***STATE SIGNIFICANT DEVELOPMENT:
Section 96(1A) Modification***

***Sydney International Convention, Exhibition
and Entertainment Precinct (SICEEP), Core
Facilities, Darling Harbour***

***Reconstruction of slabs, external alterations
and provision of loading dock security booth***

SSD 5752 MOD2

Figure 5: Approximate location of the ground floor slab to be demolished (Base source: applicants EIS)

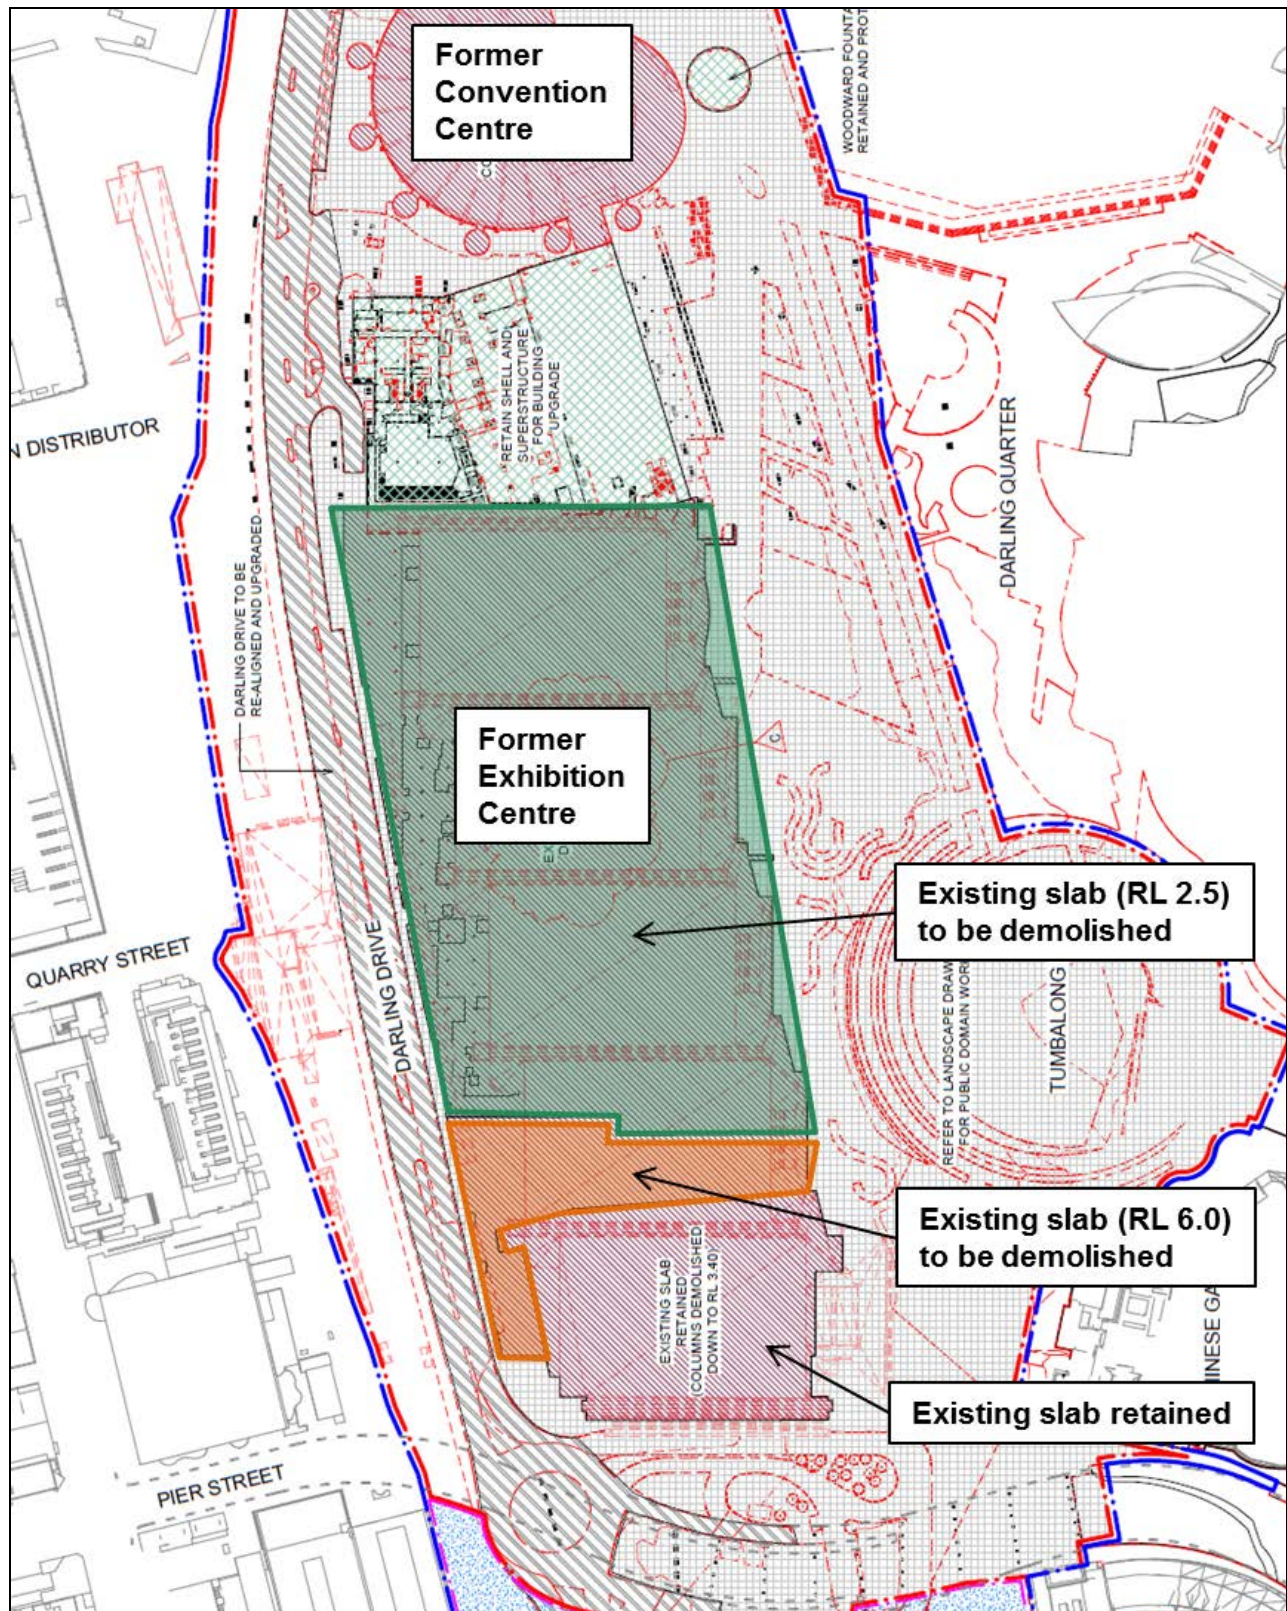
The SCIEEP Core Facilities approval includes the retention and reuse of the existing Exhibition Centre slab for the structural base of the new Exhibition Centre. Following commencement of works, the applicant has conducted further detailed structural analysis of the existing Exhibition Centre slab and found that it is not capable of supporting the required loads for the lifetime of the new Exhibition Centre and it is therefore not suitable for retention/reuse in its entirety. The proposal therefore seeks to demolish and replace the slab (refer to **Figure 5**).

The replacement slab is proposed to be constructed at the same RL as the existing slab and therefore the proposed modification is unlikely to result in any built form, visual or amenity impacts greater than previously assessed in the original application.

Figure 6: Location of proposed security booth, Core Facilities loading dock slip lane (in context with Darling Drive) and service vehicle manoeuvres (Source: applicant's further information to the EIS)

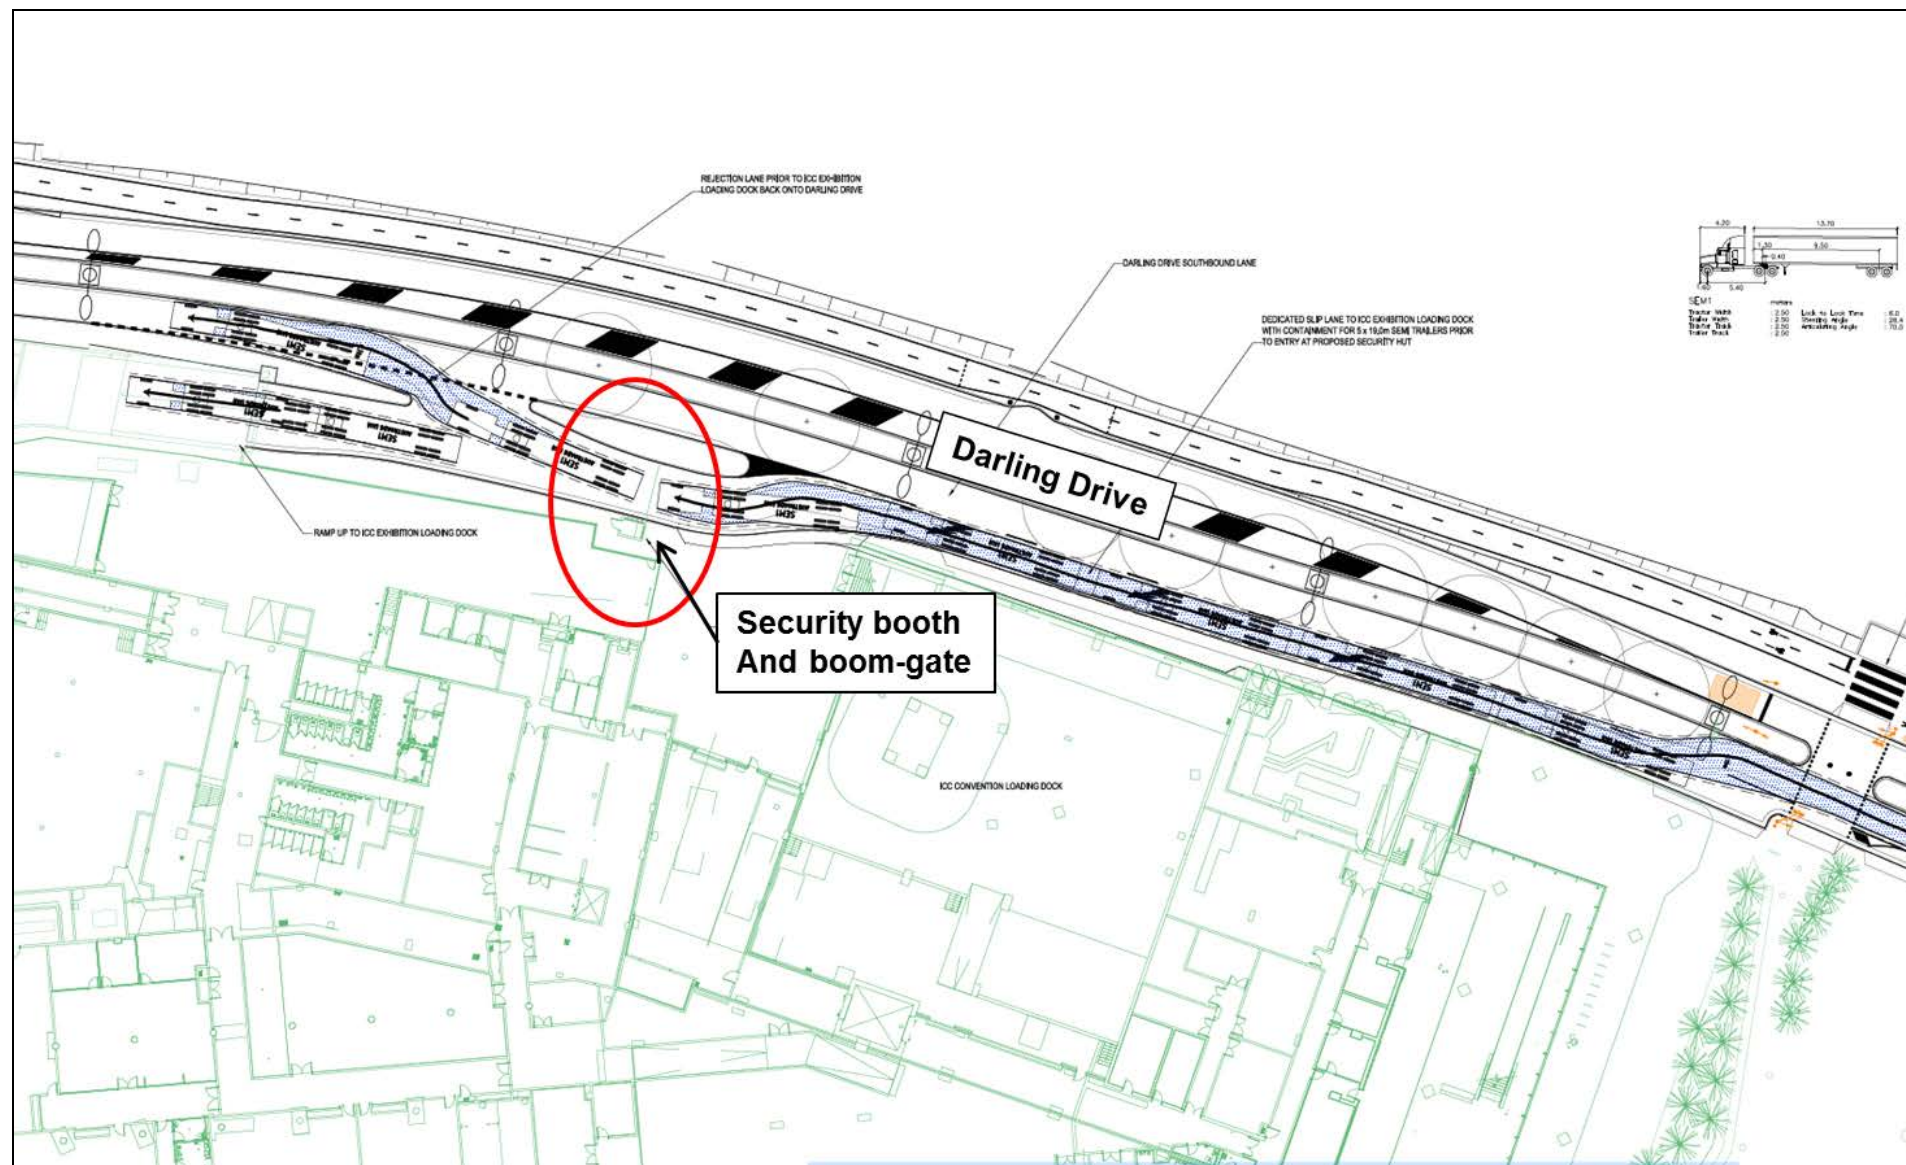
The applicant confirmed that the location of the security boom gate allows for sufficient space for service vehicles to dwell, if necessary, while waiting for security clearance without obstructing south bound traffic on Darling Drive and also allows for unauthorised vehicles to exit back on to Darling Drive (refer to **Figure 6**).

The department notes that the security booth and boom gate is necessary for the management of vehicles into the loading dock and considers that the proposal is acceptable as:

- the design incorporates a sufficient vehicle lay-by space for approximately five 19 metre service vehicles and would not therefore impact on Darling Drive; and
- the proposal will improve the security and management of the Core Facilities.

Figure 7: Western elevation of the Convention Centre and location and appearance of proposed metal screen architectural treatment (Source: applicant's EIS)

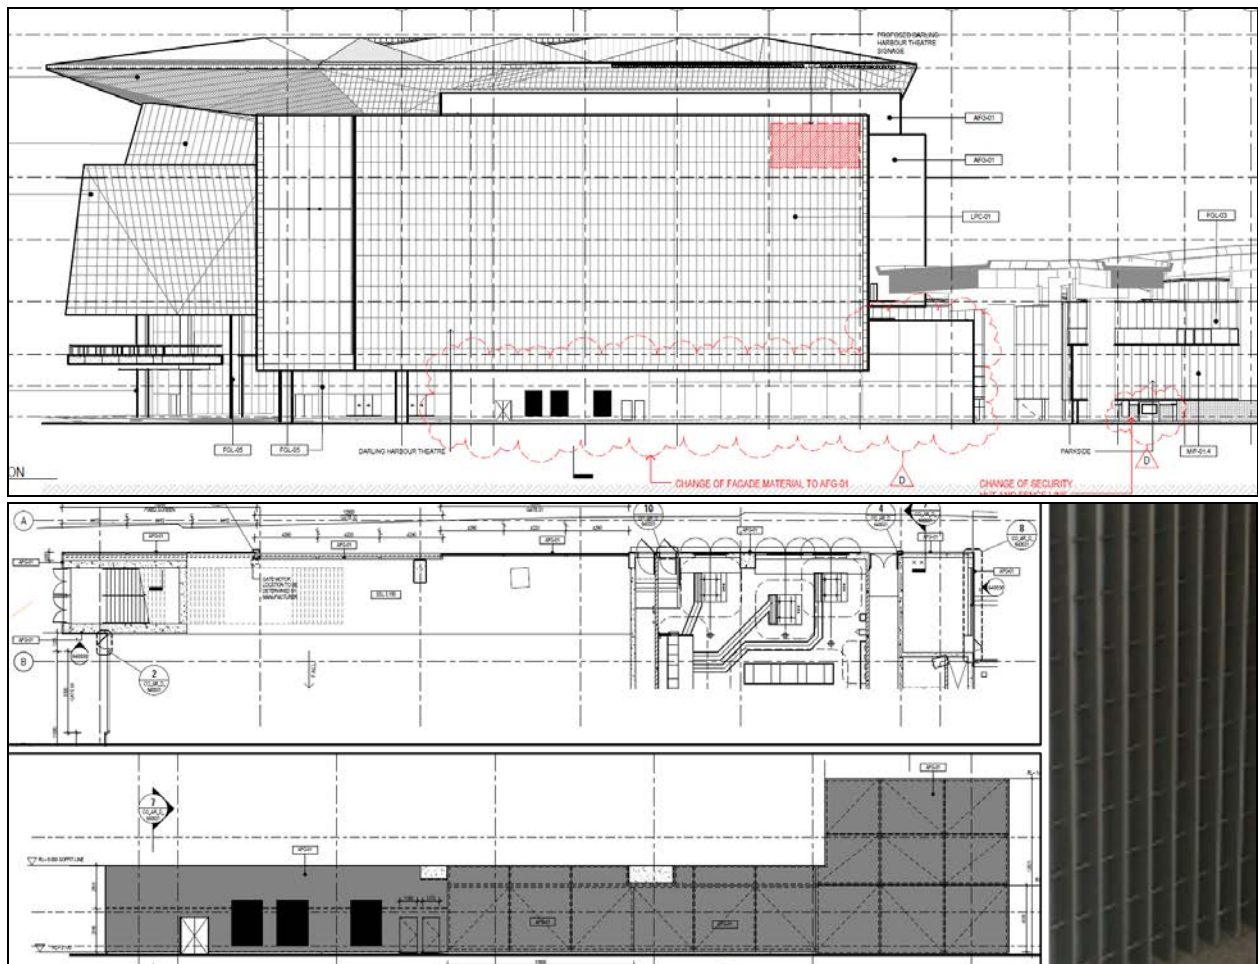
The department notes that the proposed metal screen treatment will be applied to blank concrete walls and the incorporation of this material into the design of the large sliding loading dock doors would result in a uniform material treatment for the elevation at this level. The proposed material

would have a grill-like appearance, which the department considers appropriate given the back-of-house nature of the lower levels of these facades of Convention Centre building.

The department notes that there are no other changes to the design, cladding or signage zones of the building. The department also considers that despite the external alterations, the proposed buildings maintain a similar facade and architectural design to the original approval. Accordingly, the proposed alterations do not result in any visual or amenity impacts.
